BRITISH GLIDING ASSOCIATION

TECHNICAL COMMITTEE

TNS 5/6/80

1. AIRWORTHINESS "AGGRO"

Technical Note No. 328-5

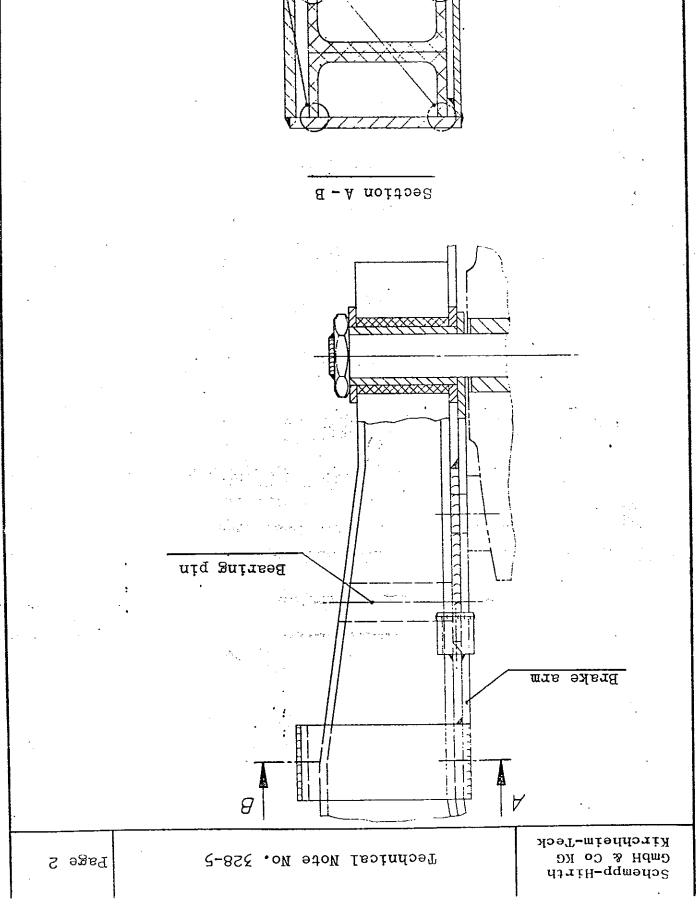
- 1.7. Mini-Nimbus Series Landing Gear. Tech. Note 328-5 (attached) draws attention to damage that may occur to front landing gear strut, by the brake arm during heavy landings, with brake on.

At heavy landings with wheel brake put on it is possible that the front landing gear strut may be damaged by the bearing pin for the brake arm. Therefore a replacement of the brake arm is recommended.

- 1. Solder off the nipple from the brake cable and take off the wheel with the brake arm.
- 2. Saw off the bearing pin for the brake arm inside of the front landing gear strut and file it down.
- 3. Put a new brake arm (drawing Mini-Nimbus HS 7 No. 10.039 A) onto the front landing gear strut (see sketch on page 2).
- 4. Mount the wheel and the brake cable and solder on again the brake cable nipple.

Brake arm in accordance with the Drawing Mini-Nimbus HS 7 No. 10.039 A.

BE -016/79 BOCIAN BULLETIN

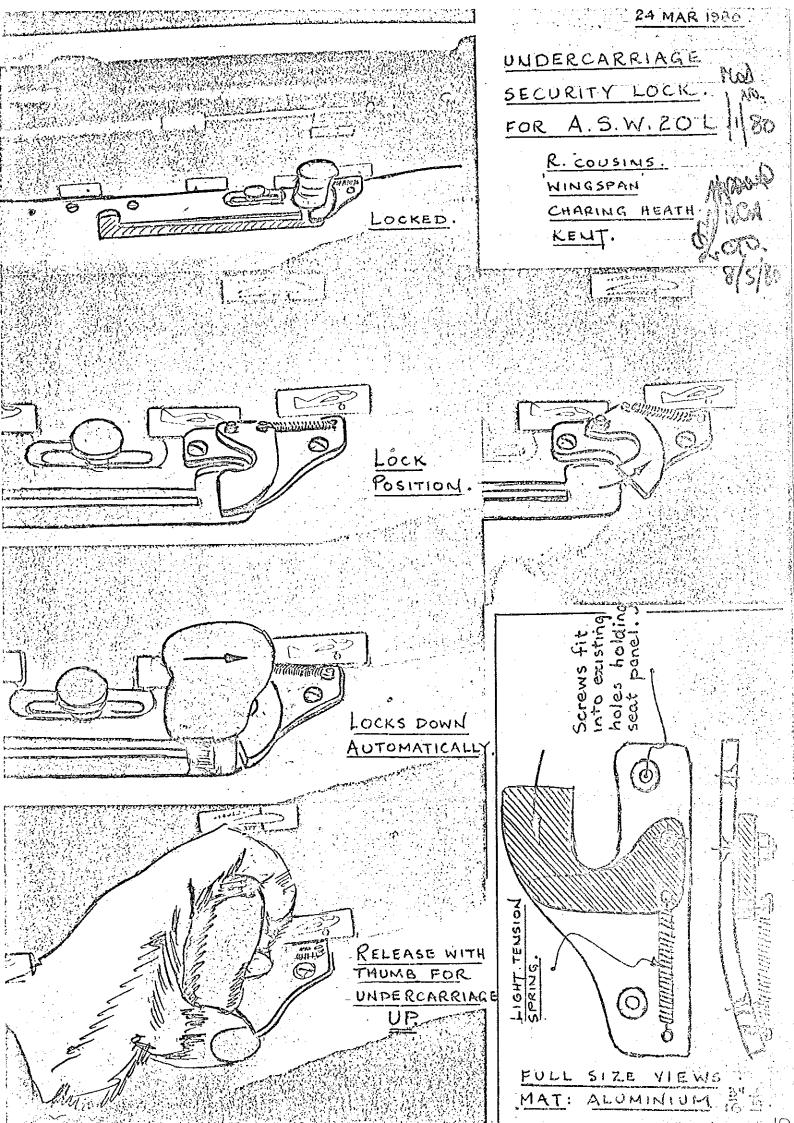
- 1.1. Bocian cracks in Centre Section Structure. Bulletin BE-016/79 and TNS 10/79, require repetitive inspection. Attached sketch illustrates cracks that may develop (Reported by R. Jarvis, S.G.U. Portmoak).

CRACK ON C/L OFWELD 1"Long Man De la Carrera TOP FRONT.

HOW TO IDENTIFY ROLLED/ MACHINED THREADS ON PIPER STRUTS.

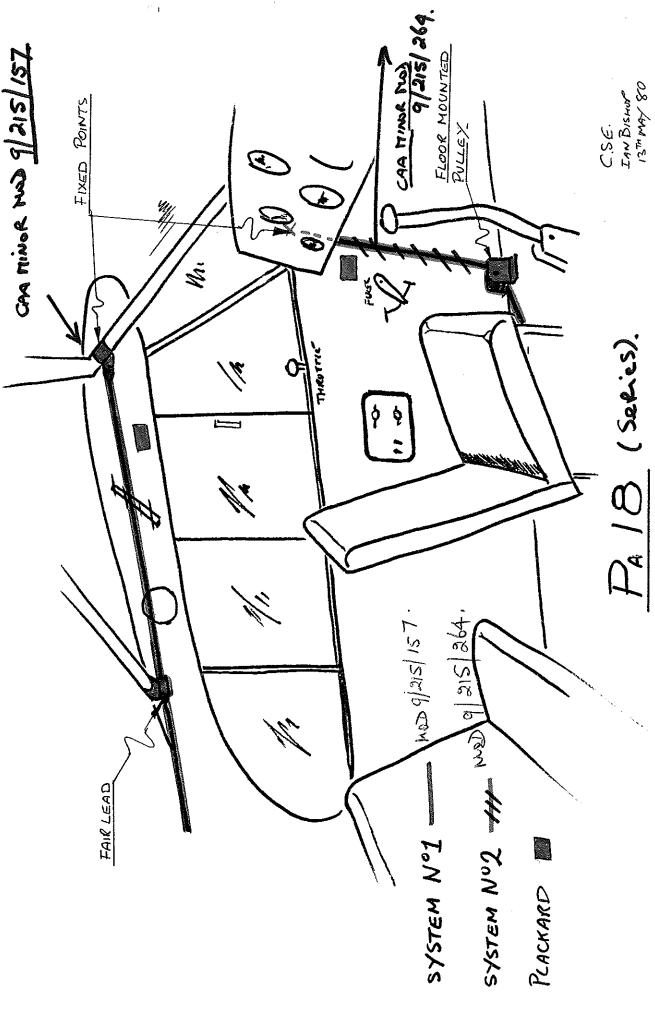
An emergency A/D has been mailed to all owners, by CAA requiring immediate inspection/replacement of the Wing Lift Strut Forks Part No: 14481-00 and Part No. 11431 (used on J4) (Contact Service Dept. C.S.E. Kidlington 4311) sketch to identify threads attached.
- Tug Flight Manuals. Amended Towing Weights. Tug owner/operators are reminded to apply to C.A.A. (Airworthiness Division),
 Brabazon House, Redhill, Surrey RH1 1SN, for the latest amendment to their Flight Manuals, authorising increased weights, dual towing etc. Ref. TNS 3/80. para. 3.6. Any queries arising on the amendments should be referred to C.A.A.

INICINIO TO: RPSM'S PIPER LIFT STRUT FROM: If ____ BUBJECT: GPDATE ON CIFT STRUT AD ROCLED THREAD FORKS CAN USUALLY BE IDENTIFIED BY THE FACT THAT THE THREAD AREA IS LARORE IN DIAMETER THAN THE SHANK, DUE TO THE THRIBD ROLLING PROCESS. ROLLED MACHINED THREADS ARE USCIALLY THE

SAME DIAMETER ASTHE FORK SHANK FROM WHICH THE MATERIAL WAS MACHINED (CUT)
